CONTRACT PLANS

FINANCIAL PROJECT ID 417545-1-52-01
SEMINOLE COUNTY (77470)

WIDEN SEMINOLE EXPRESSWAY FROM SOUTH OF ALOMA AVE. TO NORTH OF SR 434

SEMINOLE EXPRESSWAY (SR 417) WIDENING PROJECT | SIGNING & PAVEMENT MARKING PLAN (2/4) | OCTOBER 13, 2023

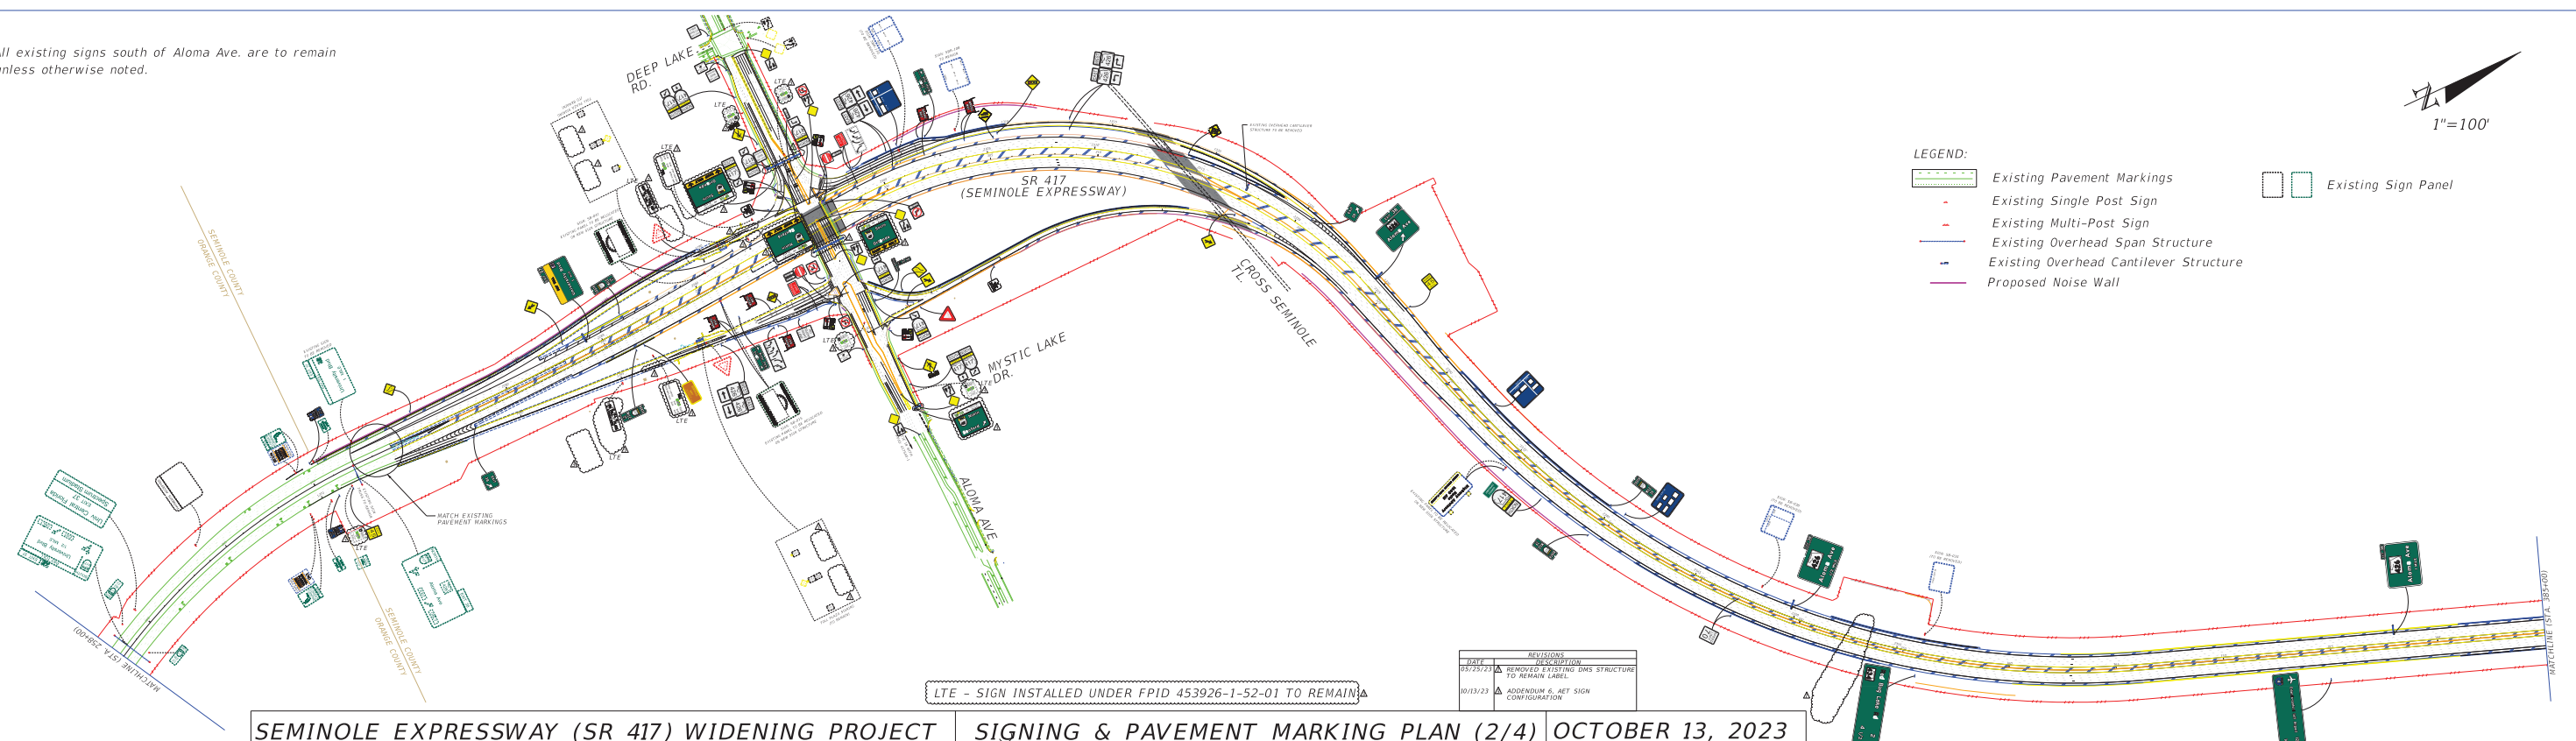
DATE	REVISIONS
09/27/23	REMOVED EXISTING SMS STRUCTURE TO REMAIN LABEL
10/13/23	ADDED SIGN E-RET SIGN CONFIGURATION

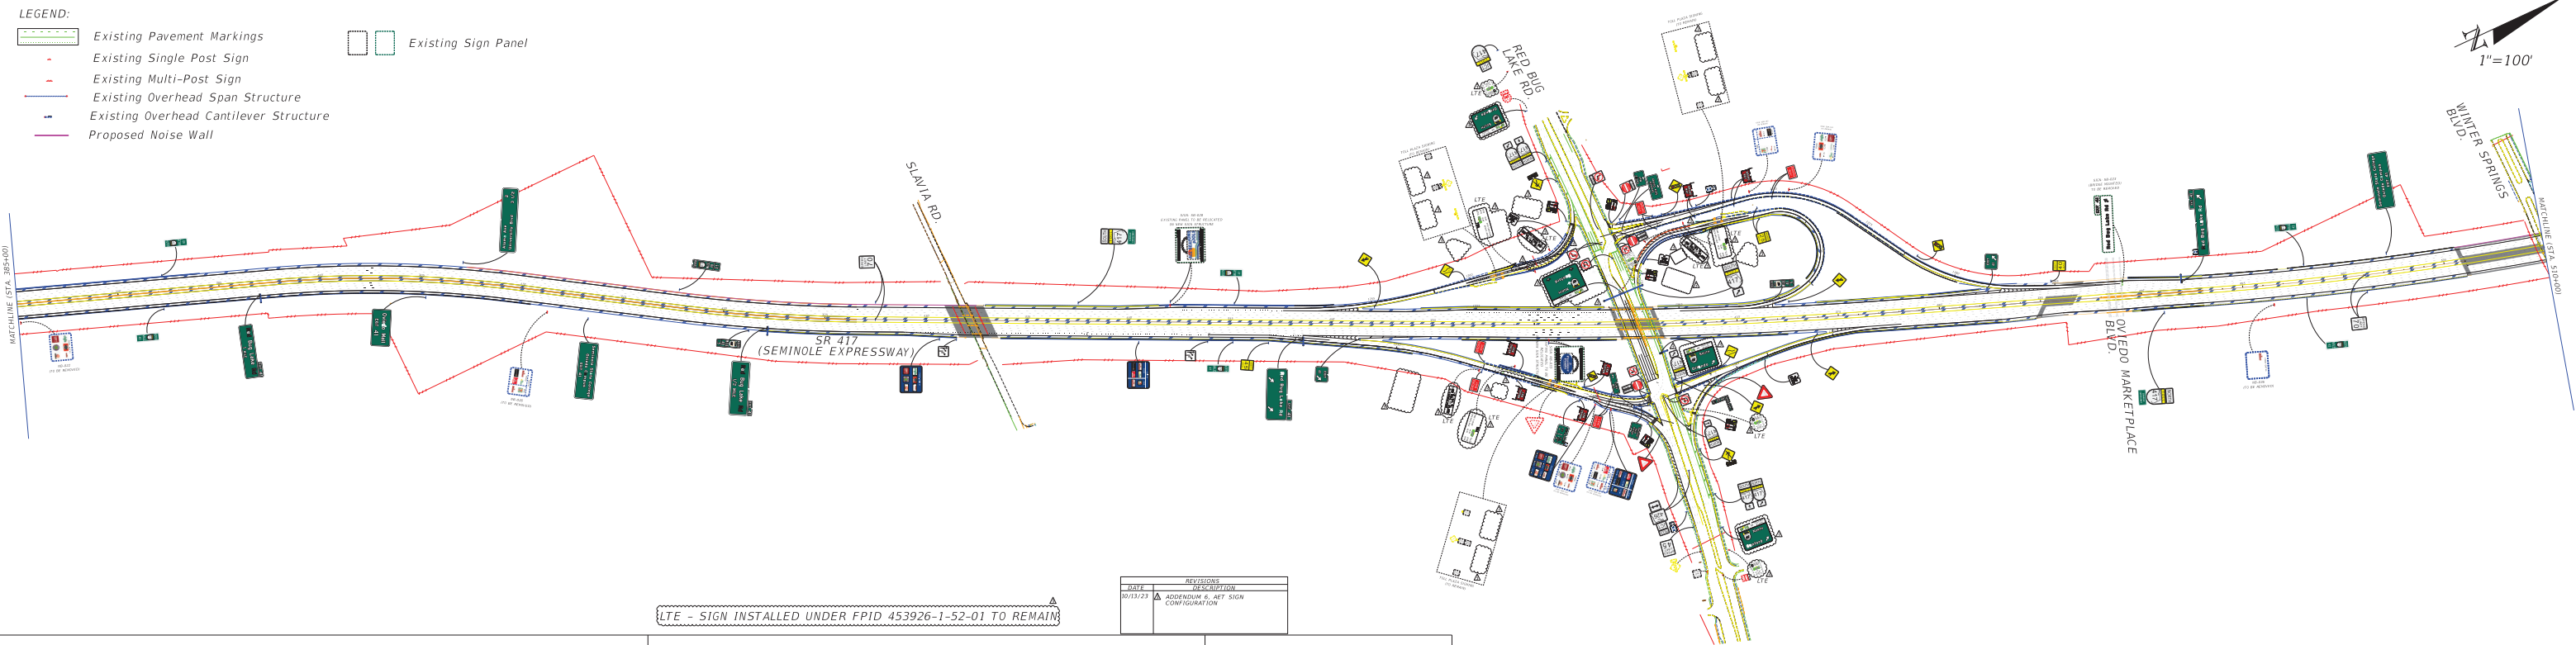
REVISIONS	
DATE	DESCRIPTION
10/13/23	ADDendum 6 - NET SIGN CONFIGURATION

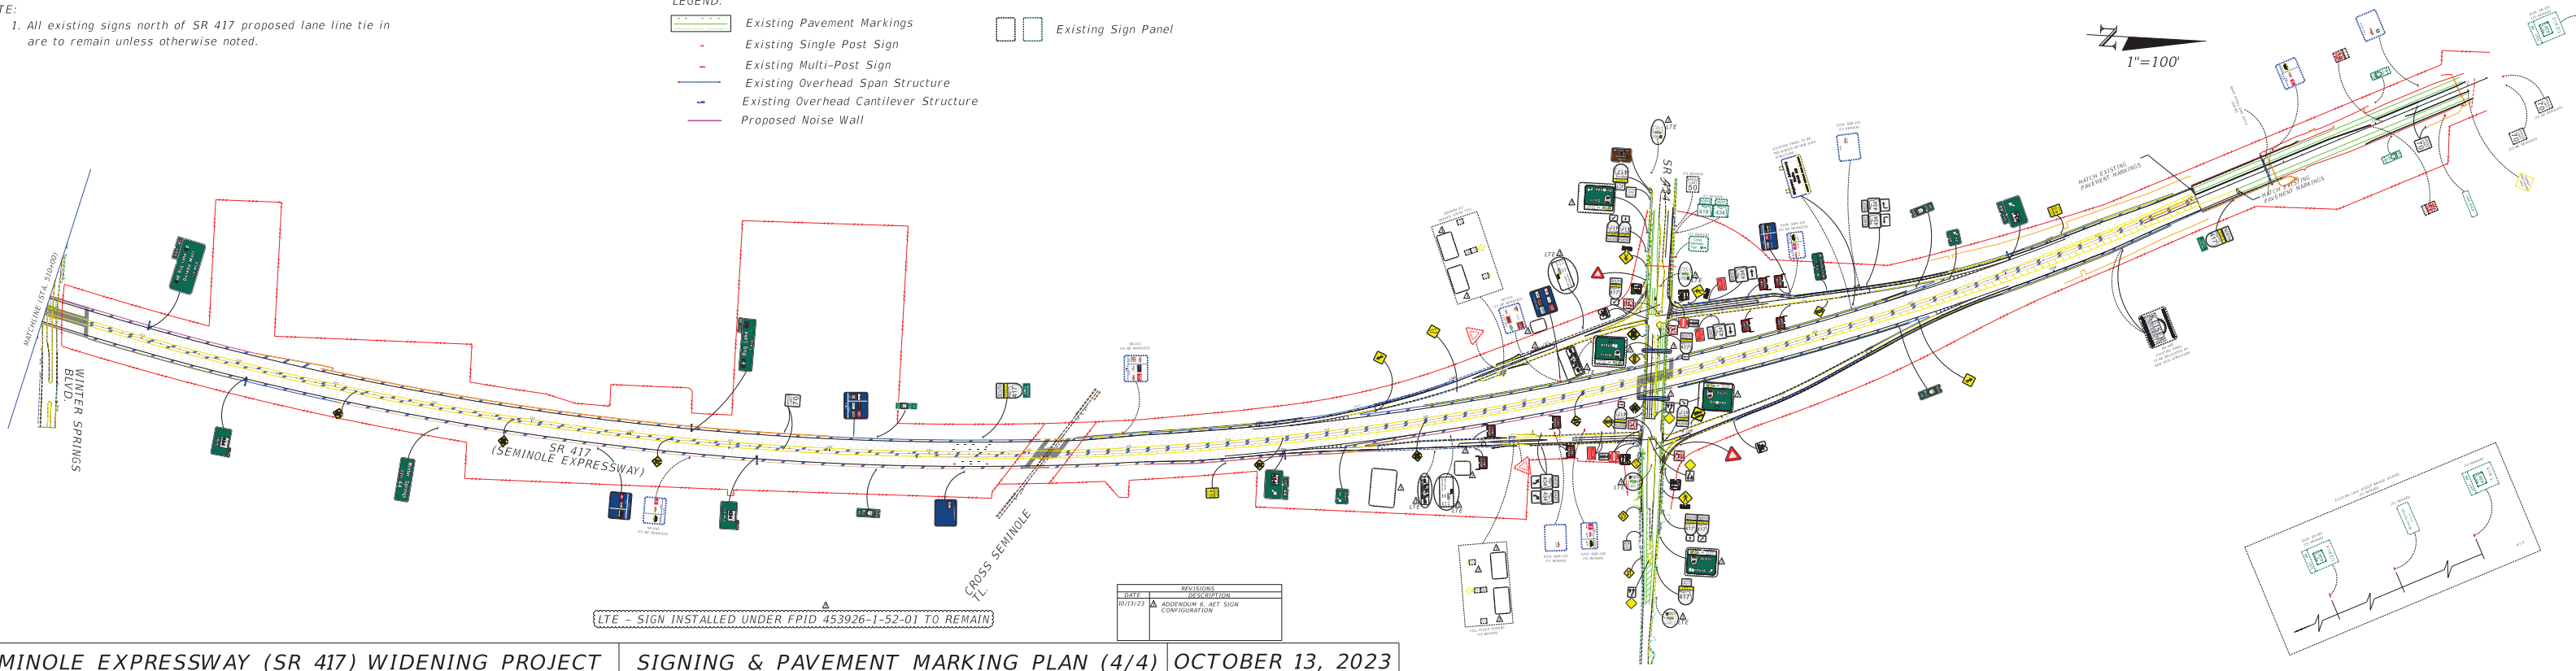
DATE	REVISIONS
DESCRIPTION	
10/13/23	ADDENDUM 6 - JET SIGN CONFIGURATION
